# ADDENDUM 1

**PROJECT NAME: Sonterra Rd Extension (Sonterra to Loop 1604)**

**DATE: 01/12/2024**

**PROJECT NO: 23-03917**

100% SUBMITTAL	PROJECT NO.: 23-01849	DATE: 01/09/2024
DRWN. BY: JLL	DSGN. BY: NS	CHKD. BY: BAG
		SHEET 80 OF 208

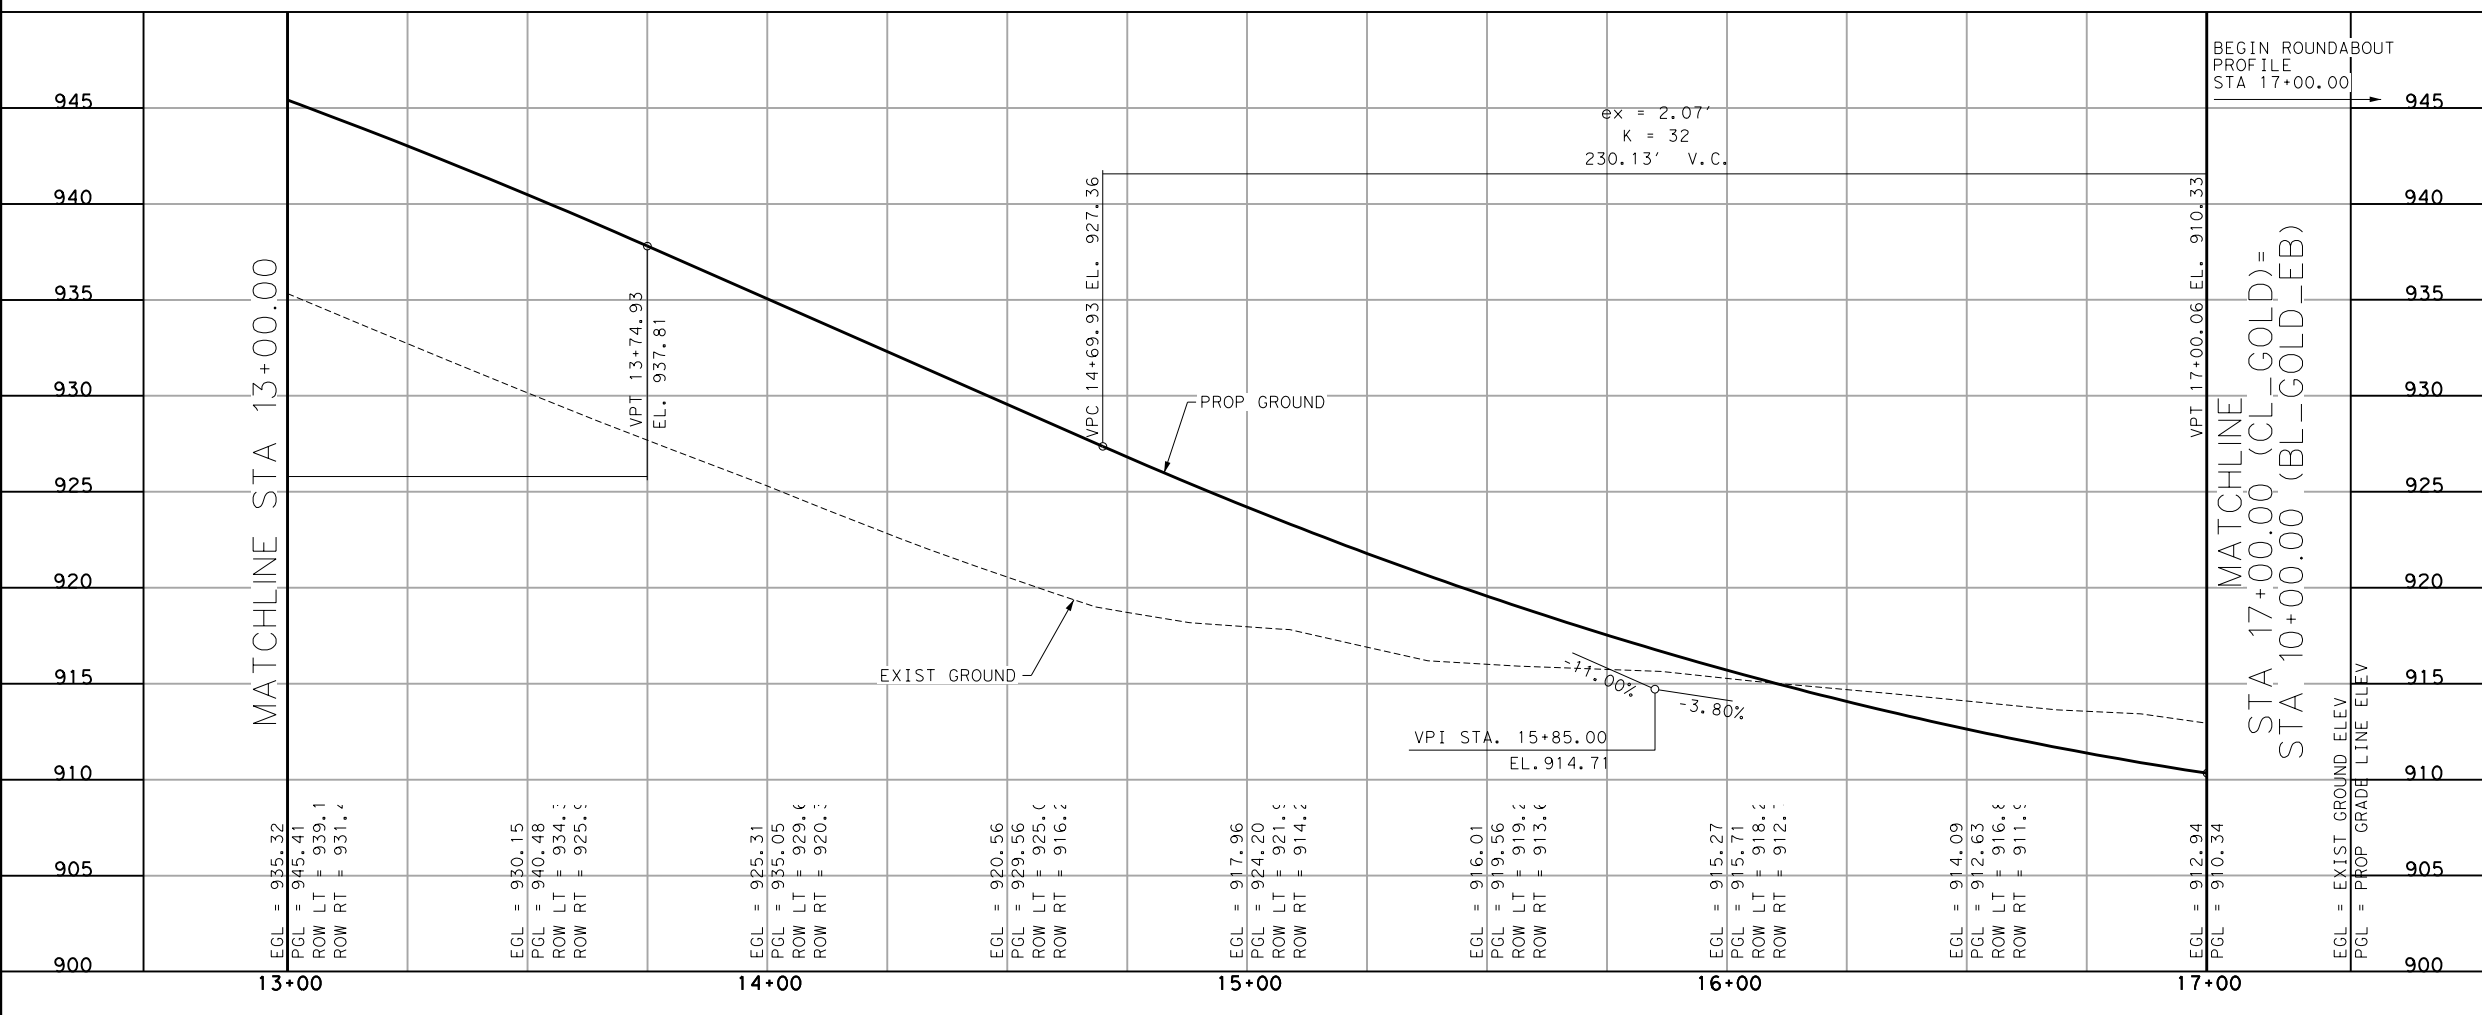
- D. REMOVE SHEET 79 AND REPLACE WITH ATTACHED SHEET 79 TO RELFECT REVISED LEGEND.
- E. REMOVE SHEET 80 AND REPLACE WITH ATTACHED SHEET 80 TO RELFECT REVISED LEGEND.

100% SUBMITTAL	PROJECT NO.: 23-01849	DATE: 01/09/2024
DRWN. BY: JL	DSGN. BY: NS	CHKD. BY: BAG
		SHEET 85 OF 208

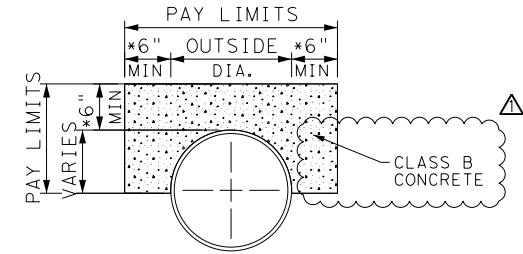
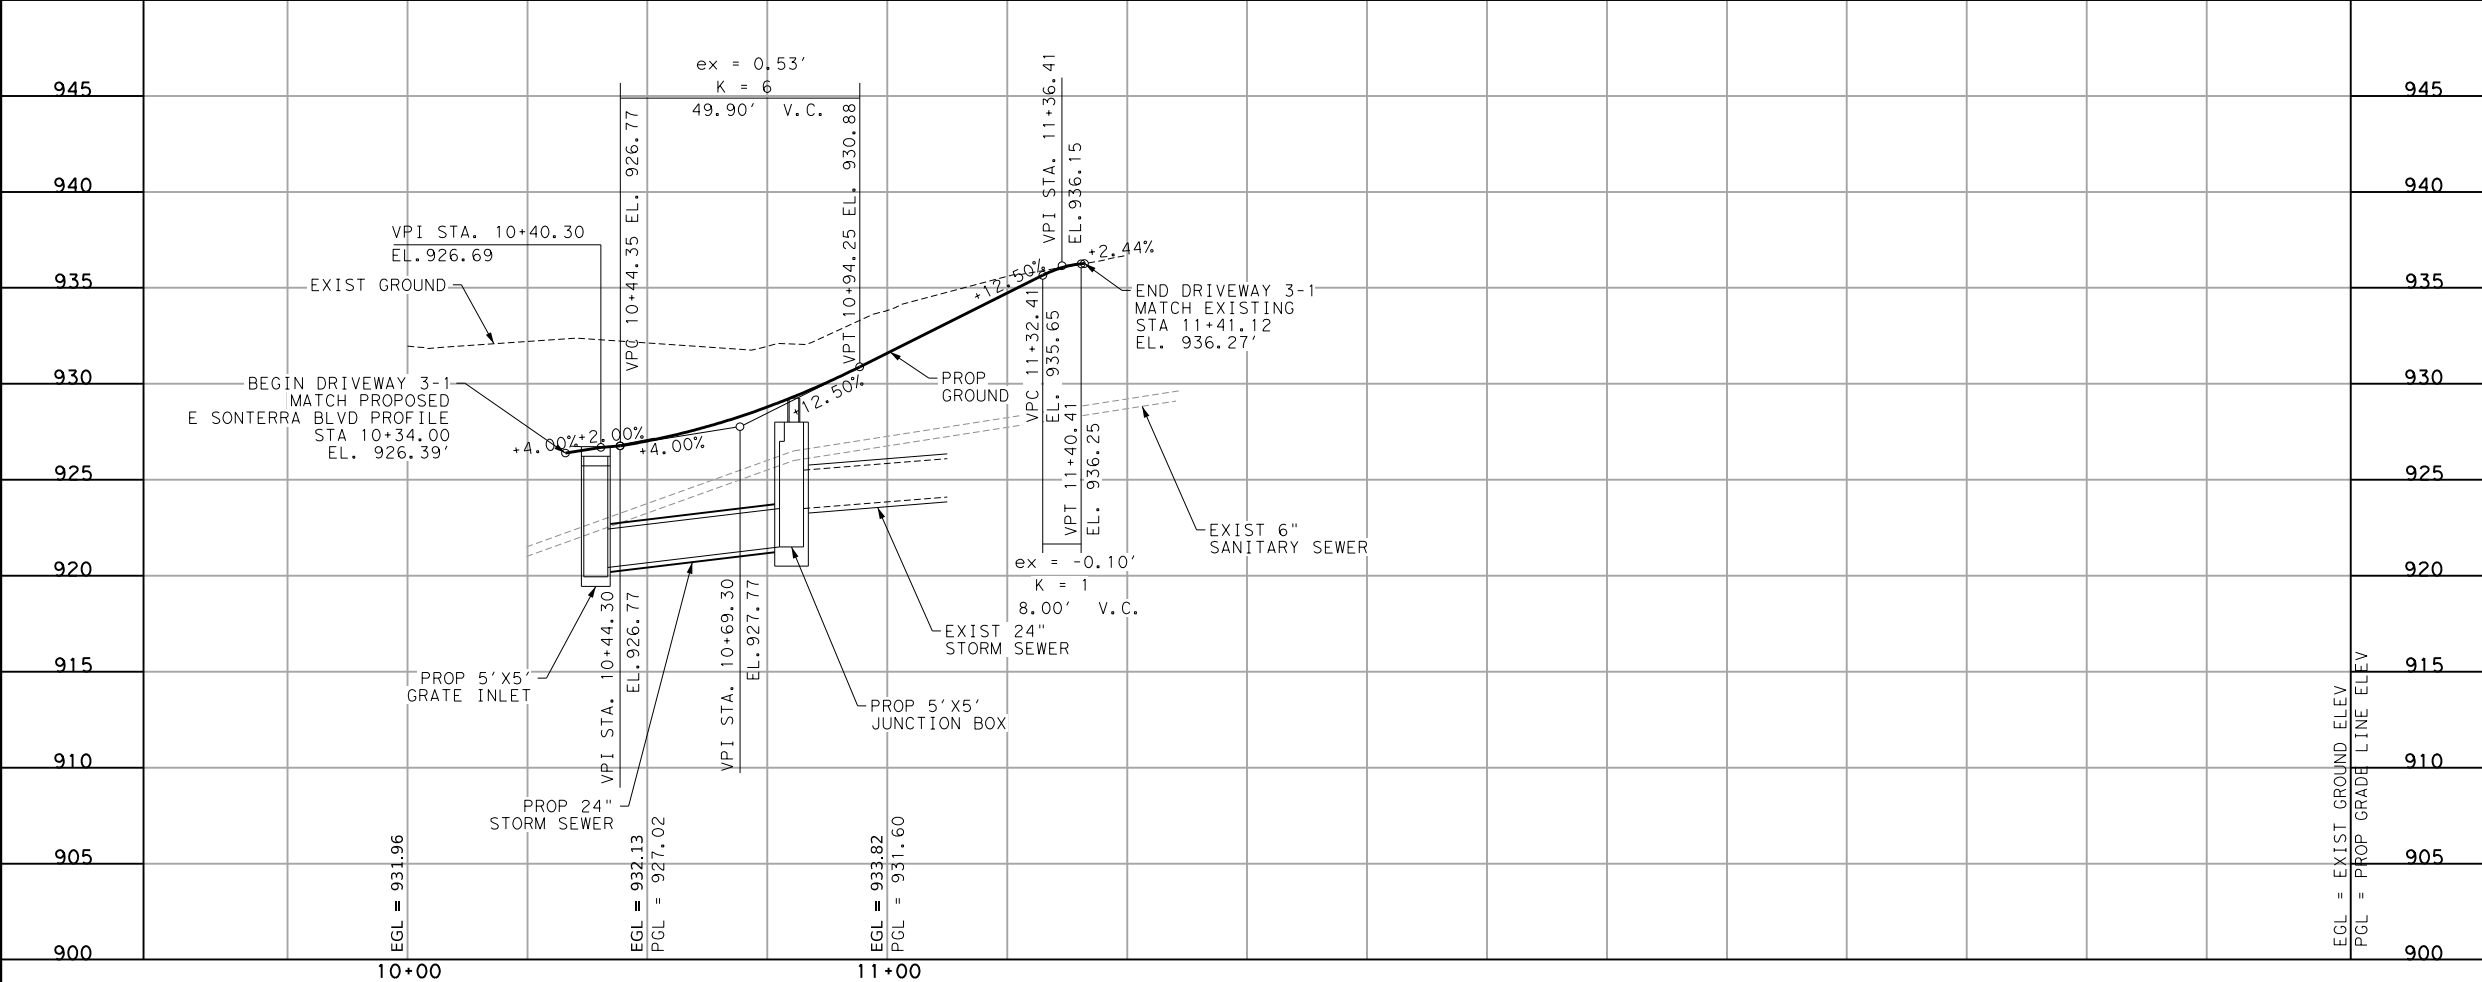
- J. REMOVE SHEET 85 AND REPLACE WITH ATTACHED SHEET 85 TO RELFECT REVISIONS TO THE LEGEND, CONCRETE CAP DETAIL, AND SHEET NOTE 1
- K. REMOVE SHEET 86 AND REPLACE WITH ATTACHED SHEET 86 TO RELFECT REVISED LEGEND.

NOTES:  
 1. CONTRACTOR TO POTHOLE AND VERIFY DEPTH OF EXISTING ELECTRICAL CONDUIT AND FIBER OPTIC DUCT AND PROTECT UTILIZING CONCRETE CAP DETAIL ON THIS SHEET. THIS WORK SHALL BE PAID FOR DIRECTLY UNDER ITEM 407.1 CONCRETE ENCASEMENT.  
 2. CONTRACTOR TO PROTECT EXISTING ILLUMINATION POLES IN PLACE.

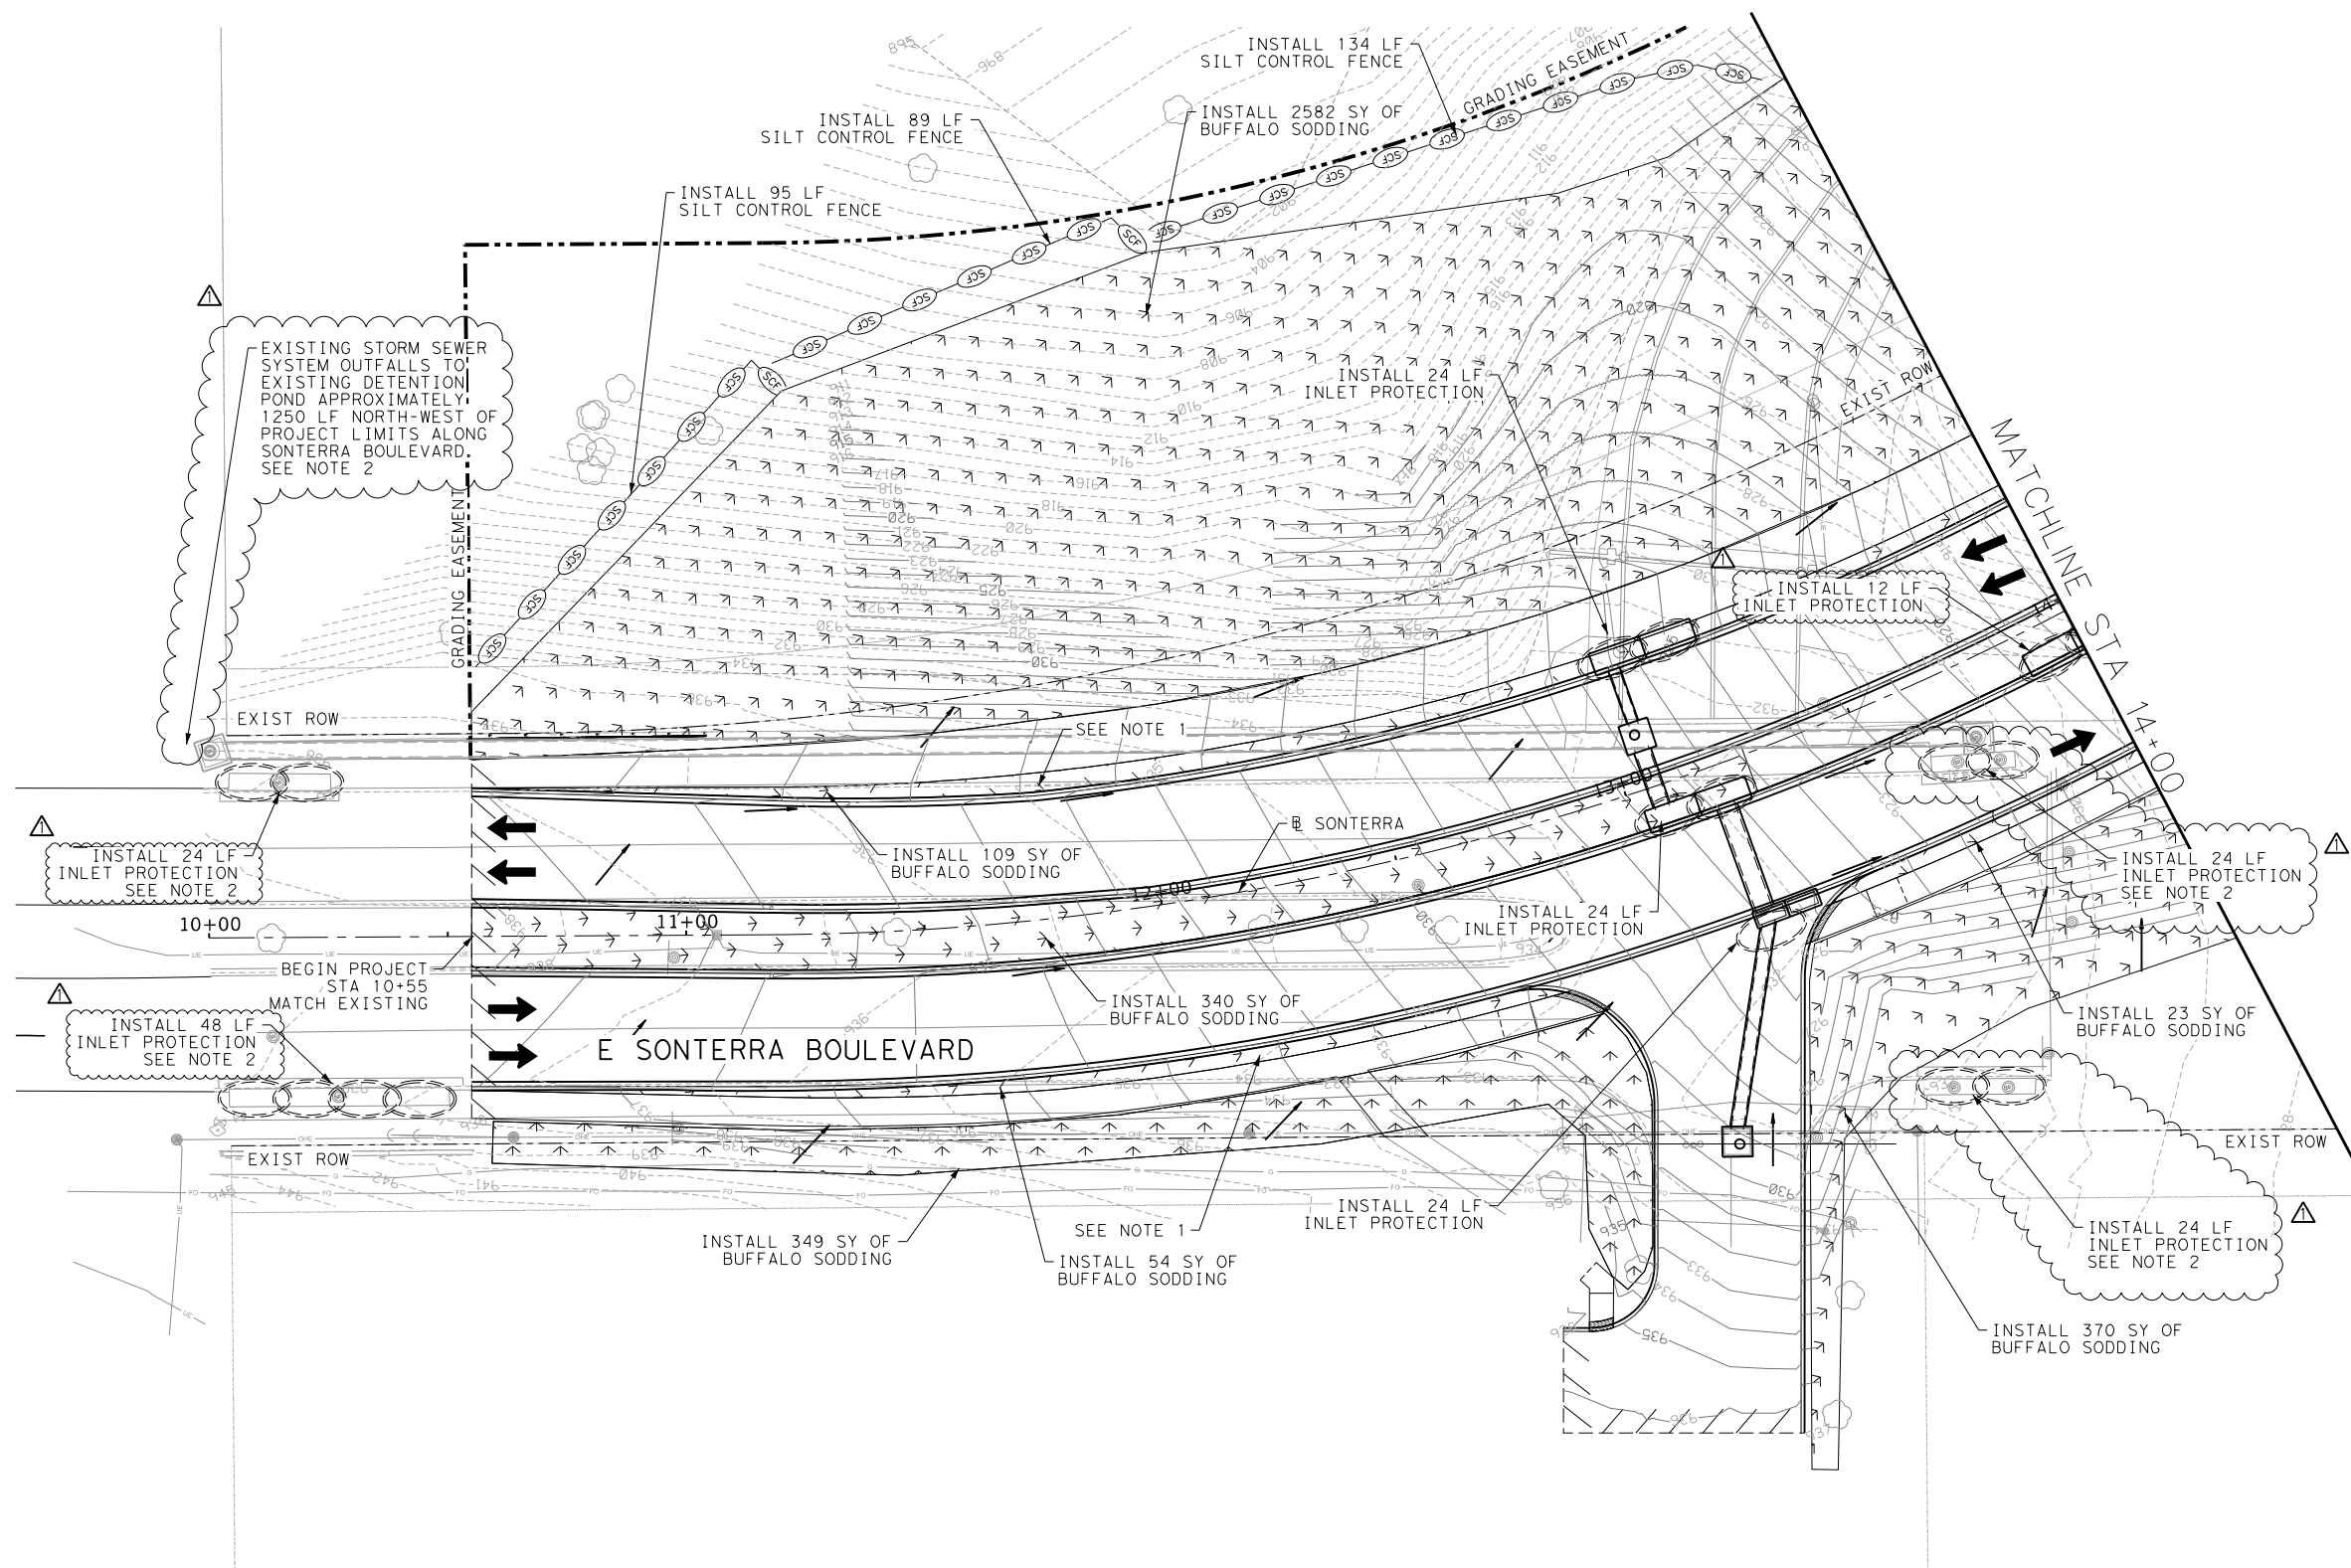
- C. REMOVE SHEET 147 AND REPLACE WITH ATTACHED SHEET 147 TO REFLECT REVISED BID ITEM QUANTITY FOR ITEM 540.1, REVISED CALLOUTS, AND REVISED SHEET NOTES.

SW3P QUANTITIES			
ITEM NO	DESCRIPTION	UNIT	QUANTITY
515.1	TOPSOIL (4")	CY	426
516.3	BUFFALO SODDING	SY	3827
540.9	TEMPORARY SEDIMENT CONTROL FENCE	LF	318
540.1	CURB INLET GRAVEL FILTERS	LF	204
